SUNDRY NOTICES AND REPORTS ON WELLS
Do not use this form for proposals to drill or to re-enter an abandoned well. Use form 3160-3 (APD) for such proposals.

| 3b. Phone No. (include area code) Ph: 281.366.7148 | | 8. Well Name and No. GALLEGOS CANYON UNIT 296 |

PLUG AND ABANDONMENT PROCEDURE

Re: Permanent Abandonment
Well: Gallegos Canyon Unit 296

Proposed P&A West Kutz Pictured Cliffs

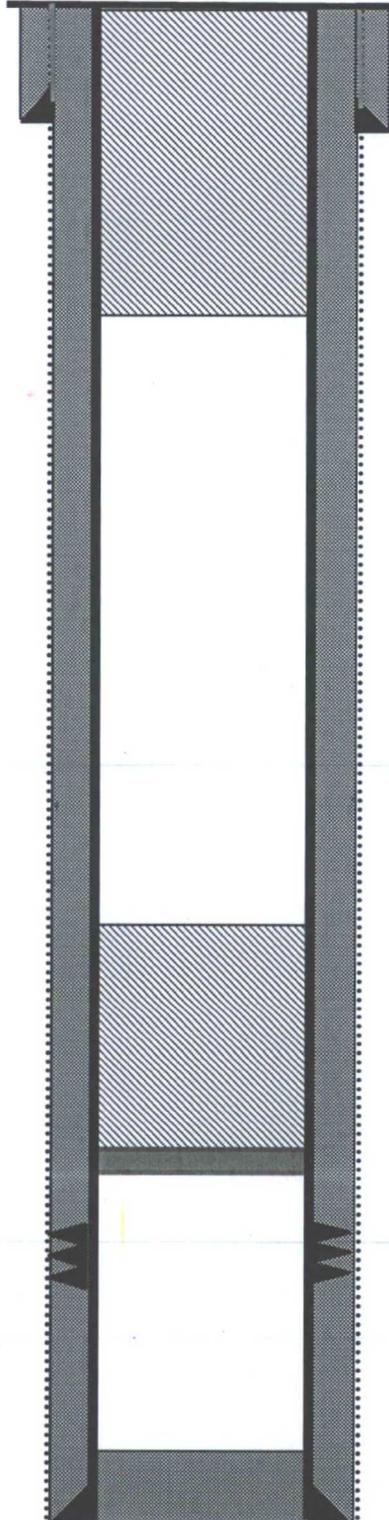
1. Plugging operations authorized are subject to the attached "General Requirements for Permanent Abandonment of Wells on Federal and Indian Lease."
2. Farmington Office is to be notified at least 24 hours before the plugging operations commence (505) 564-7750.
3. The following modifications to your plugging program are to be made:
 - a) Set Plug #2 (322 – 0) ft. to cover the Kirtland top and the entire Ojo Alamo interval. BLM picks top of Kirtland at 272 ft. BLM picks top of Ojo Alamo at 170 ft.

You are also required to place cement excesses per 4.2 and 4.4 of the attached General Requirements.
